COUNTY OF ALBEMARLE  
Department of Community Development  
MEMORANDUM

TO: Sean Dougherty – Senior Planner  
FROM: Jack M. Kelsey, PE – County Engineer  
DATE: 15 June 2005  
SUBJECT: Belvedere ZMA 2004-00007

SKETCH OF BELVEDERE BOULEVARD  
FROM RIO ROAD TO ROUNDABOUT #1

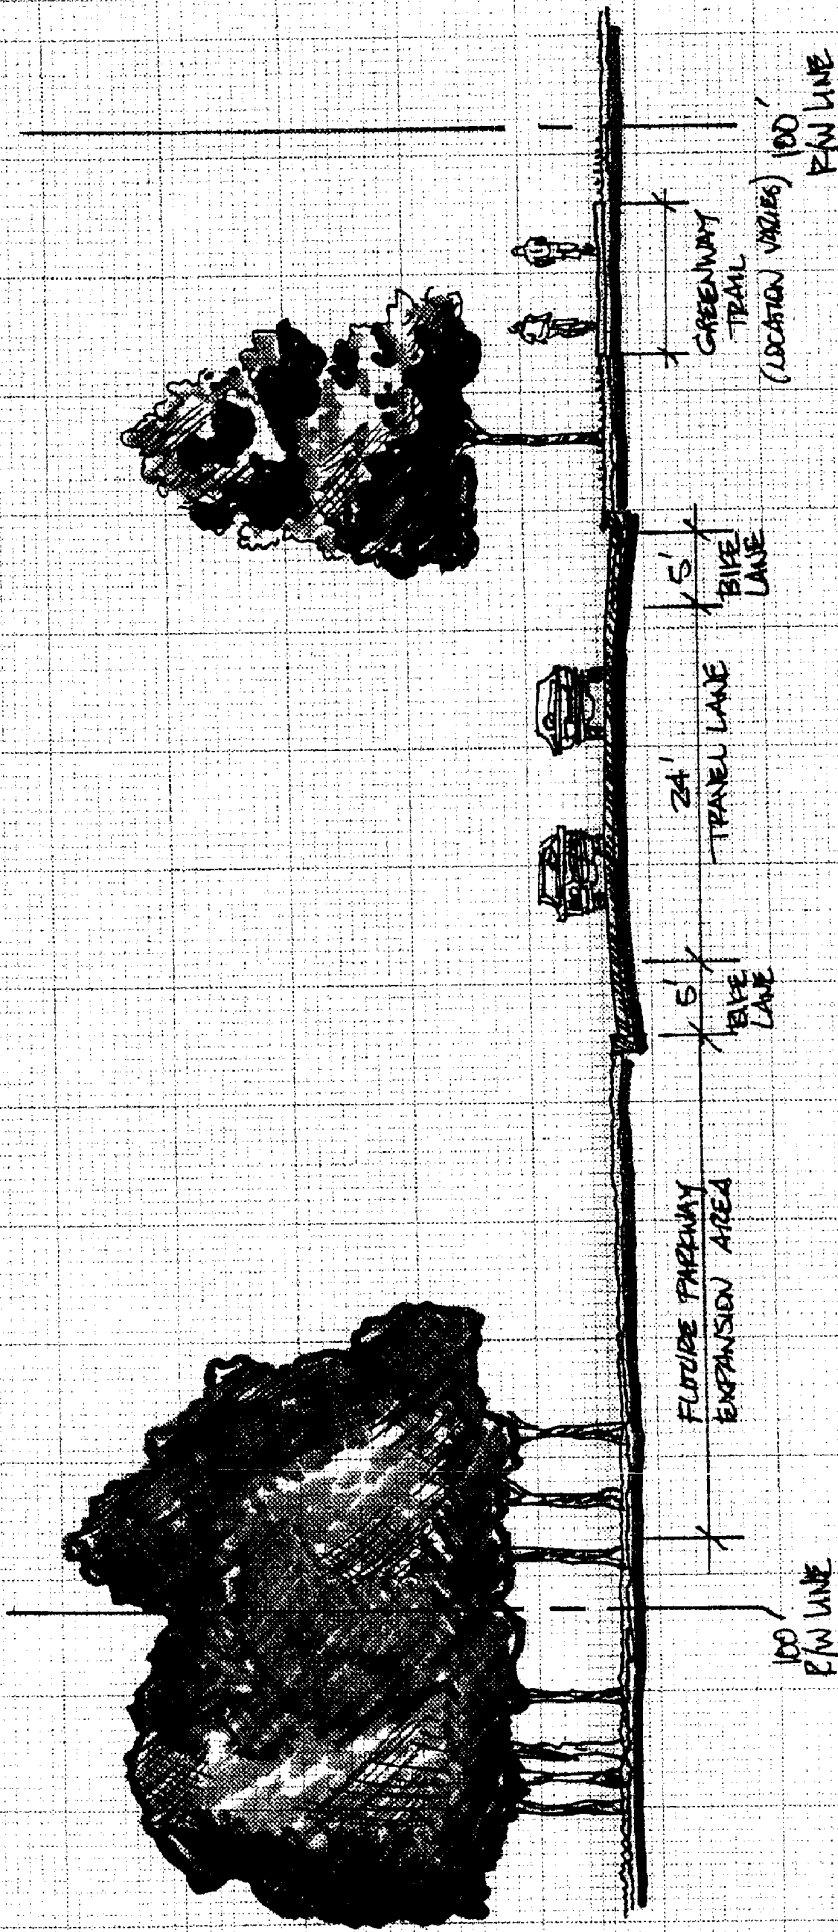
**Belvedere Boulevard - Meadow Creek Parkway/Free State Connector:**

The street cross section for Belvedere Boulevard between Rio Road and Roundabout #1 has been revised in both Table and in Exhibit 11-Detail #1 to match the cross section for the Phase 1 - Meadow Creek Parkway. A 100 foot right-of-way reservation is also being provided in the plan and proffers in the event the cross section needs to be widened. However, in our April 25<sup>th</sup> meeting we requested that the road improvements and the multi-use trail be shifted to the east side of the 100 right-of-way reservation. In this manner a greenway would be created along the railroad right-of-way that will remain for public benefit if future expansion of the parkway section is not needed (see attached sketch). This shift in the improvements was not illustrated in Exhibit 11-Detail #1 or in the street plan view provided in Exhibit 13.
